A57 Link Roads

TR010034

**9.60 Applicant's responses to Examining
Authority's Second Written Questions**

March 2022

Times shown in minutes and seconds

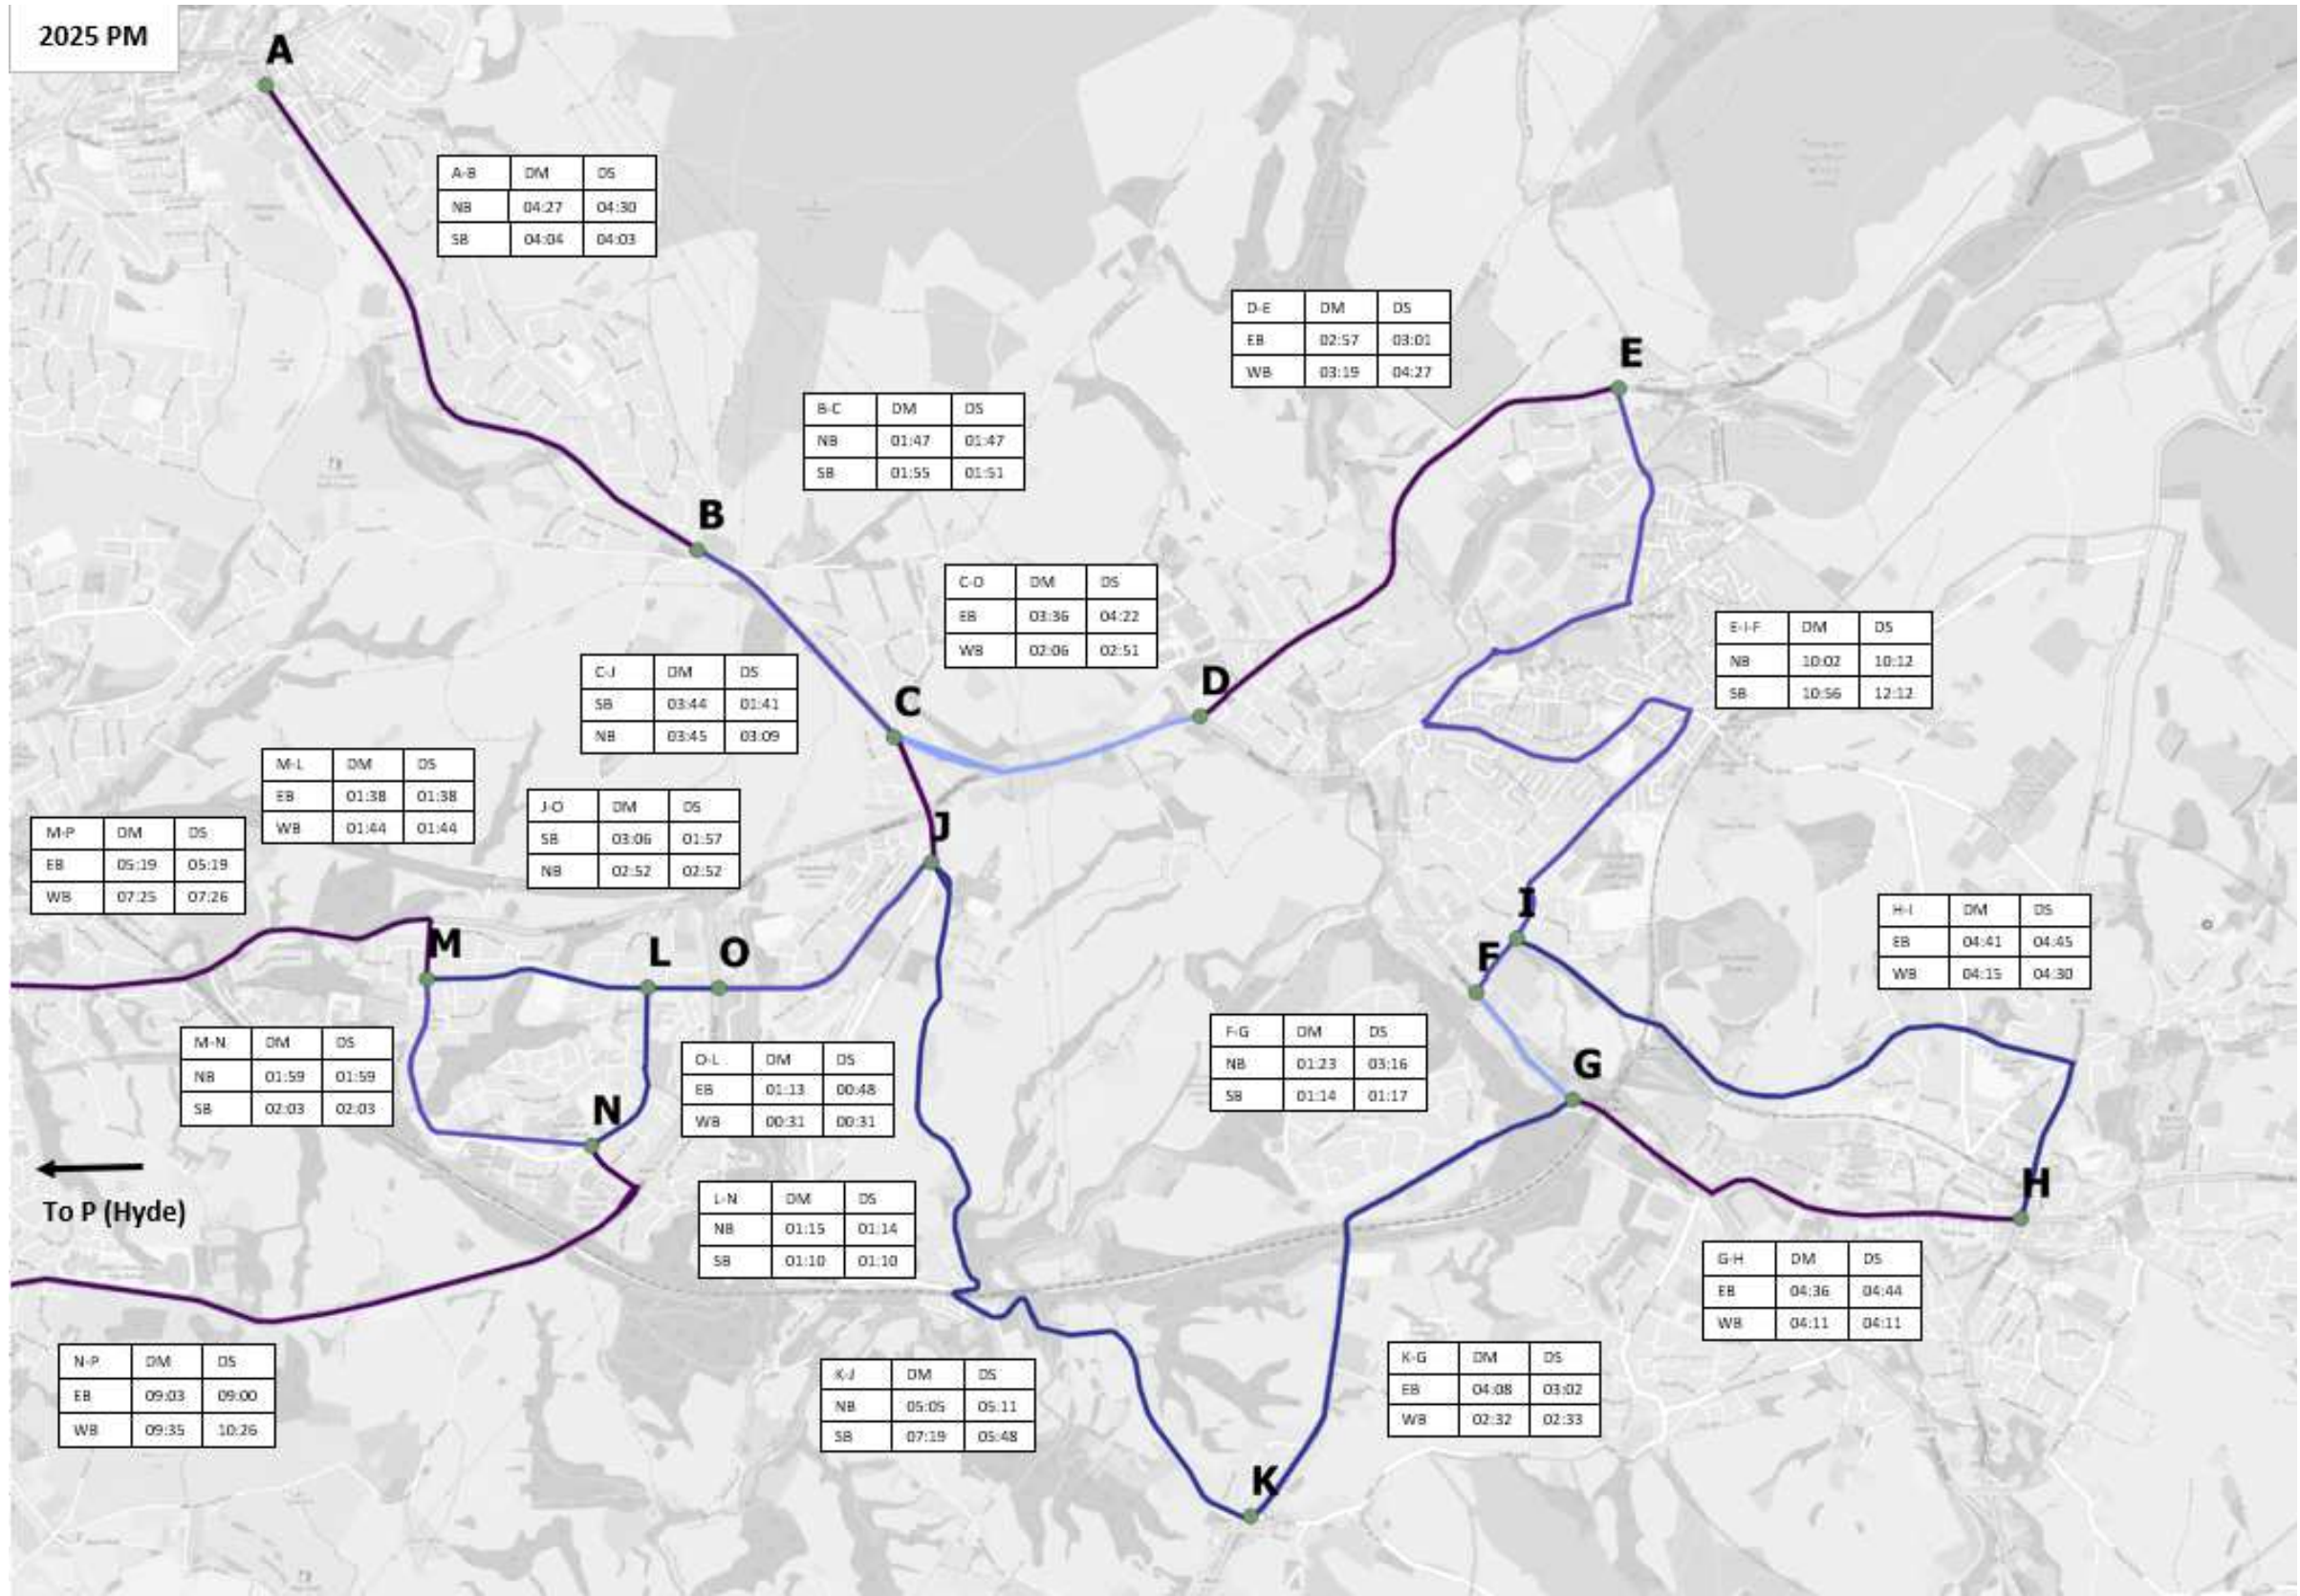
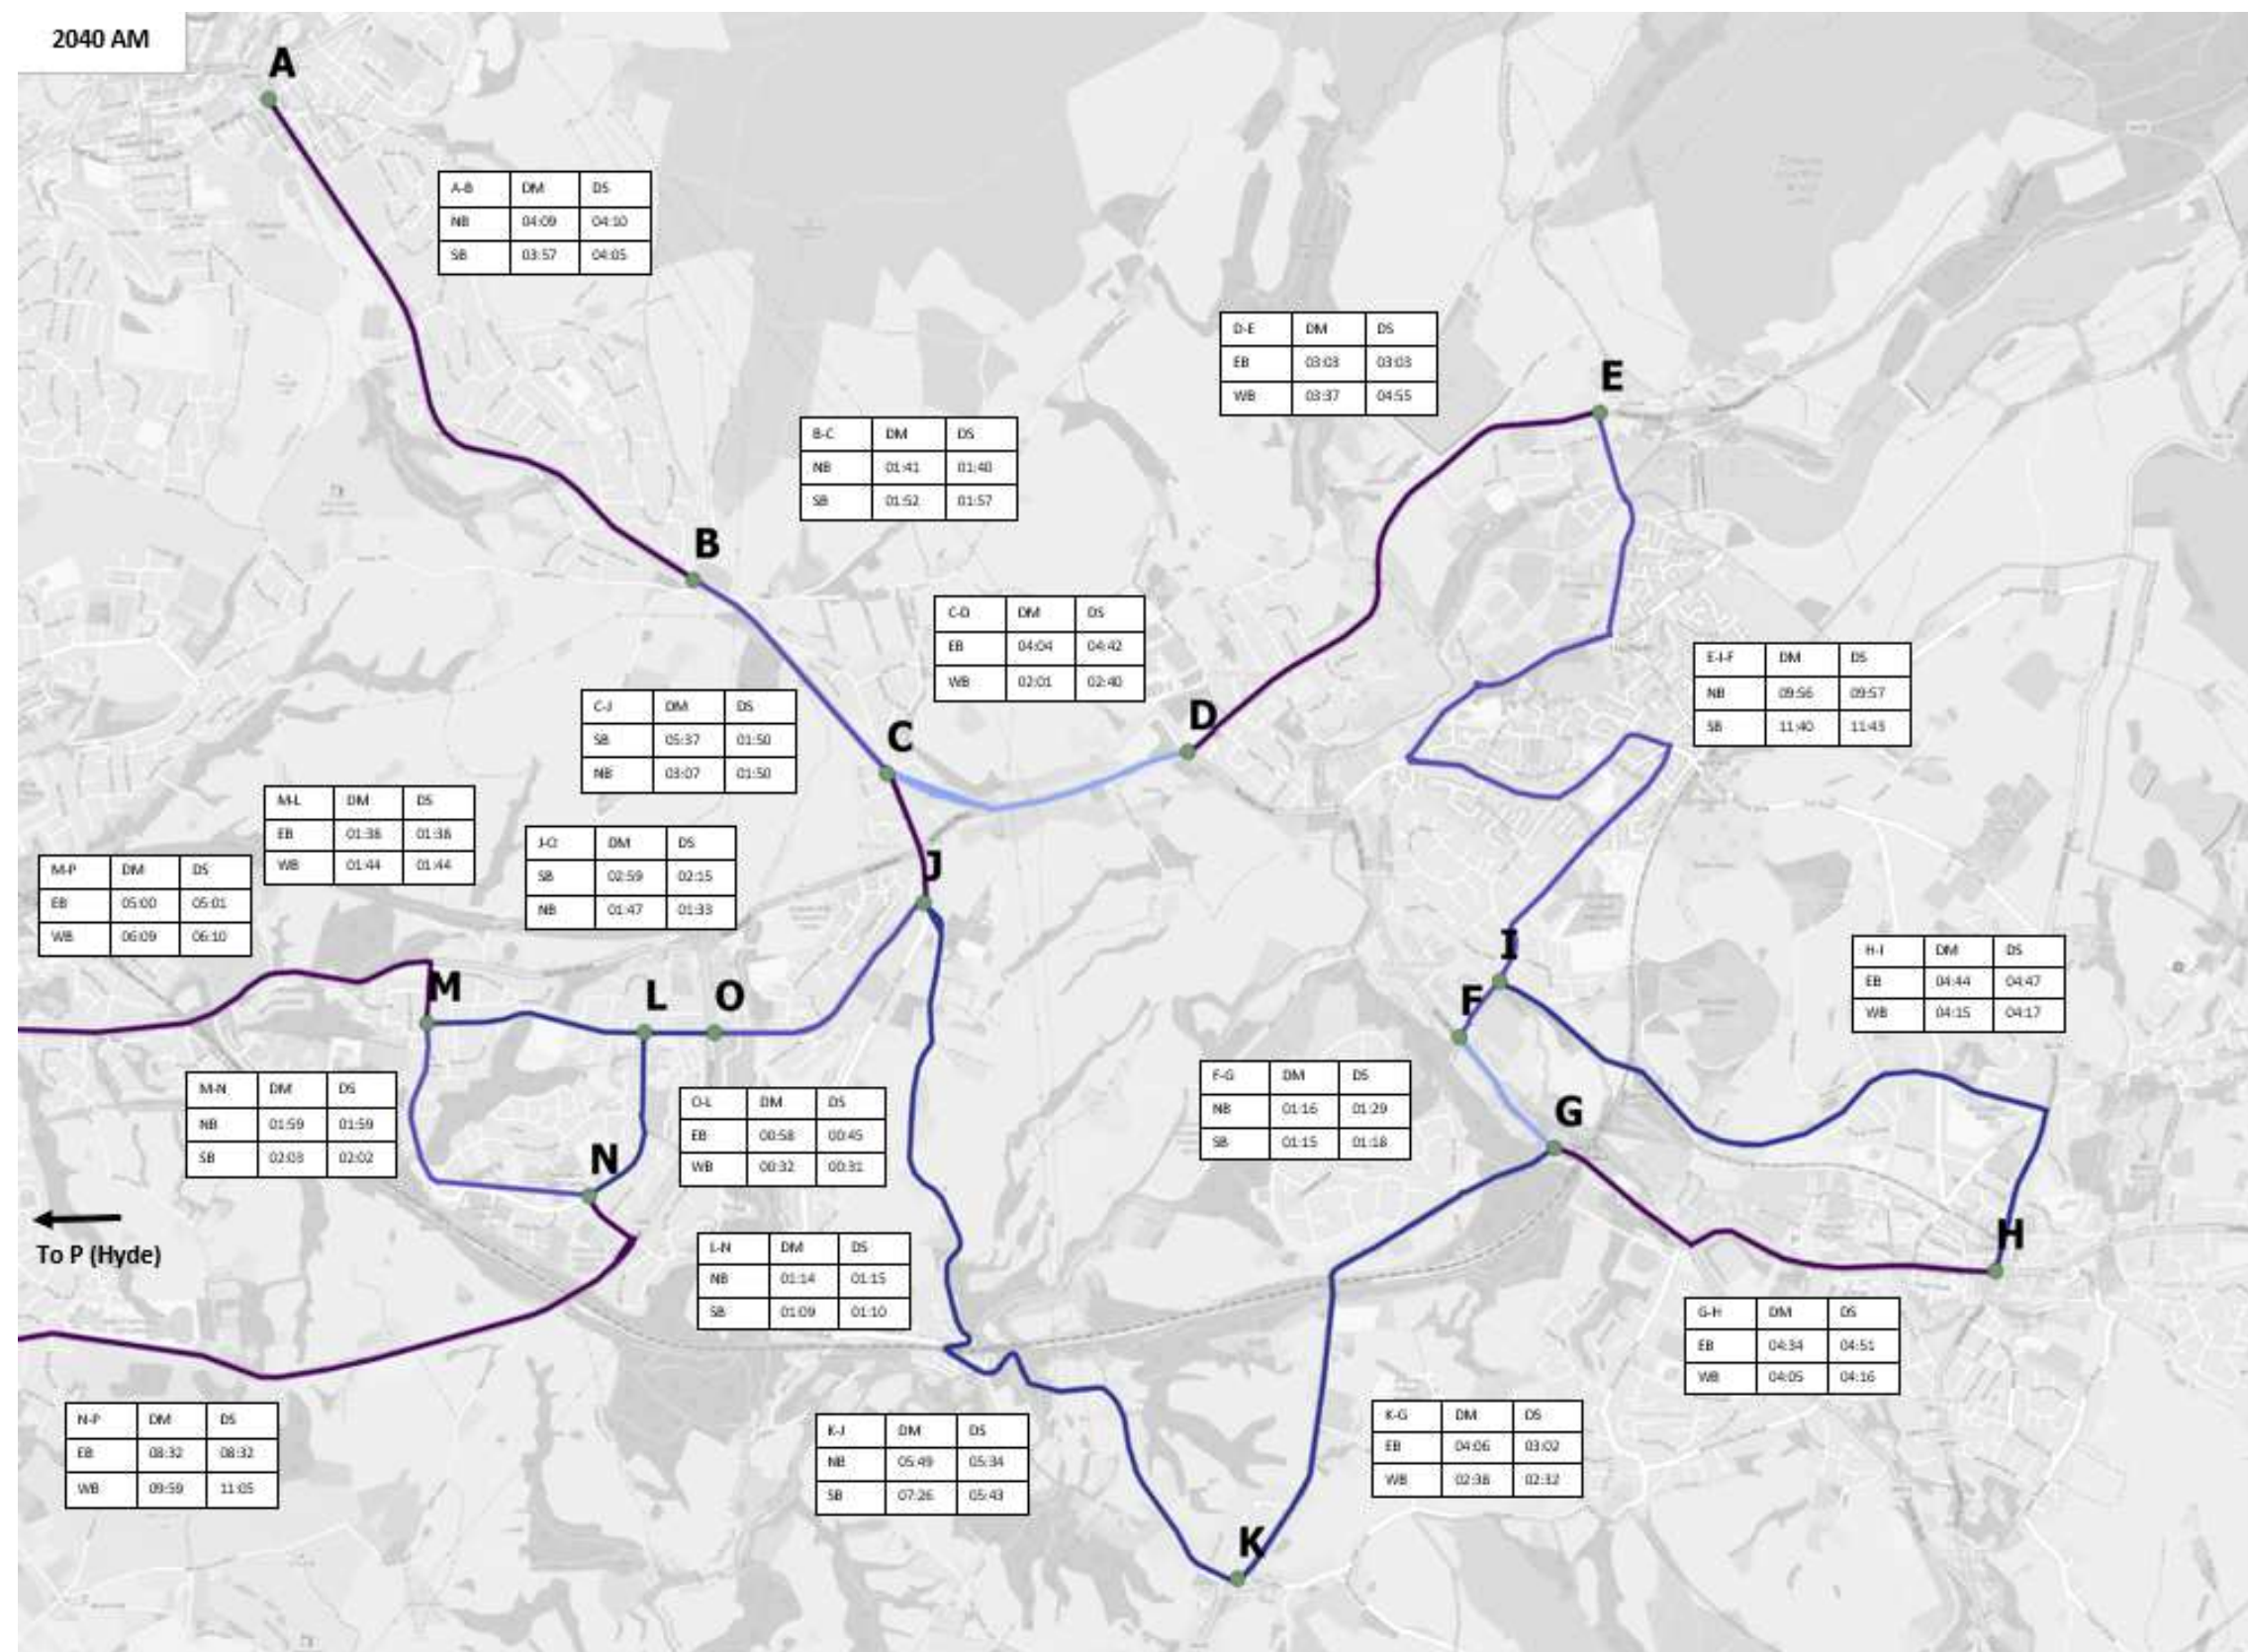
No	Question to	Reference	Question	National Highways' response																																																																																																																																																
3. Transport networks and traffic, alternatives, access, severance, walkers, cyclists, and horse riders																																																																																																																																																				
Public transport																																																																																																																																																				
3.17	Applicant	Bus journey times	<p>It is likely that buses will remain on routes using the existing road network, rather than using the links provided by the proposal. The information provided on bus travel times within the application is limited.</p> <p>Please provide, preferably in diagrammatic form, a breakdown of link journey times for local bus routes, showing, for each link, predicted journey times for the Do-Minimum and Do-Something scenarios, in opening and design years for journeys within the Local Study Area.</p>	<p>The tables below present the anticipated whole route changes in bus journey times due to the Scheme for the AM, Inter and PM peak periods for both 2025 and 2040. The changes in journey times presented are only those for when the bus is travelling on roads included in the traffic model. They excludes bus dwell times at bus stops and journey times where the buses are travelling along streets in residential areas not included in the traffic model, which are not anticipated to change due to the Scheme.</p> <p>Plans showing these changes in bus journey times by route sections (links) are provided in Appendix A.</p>
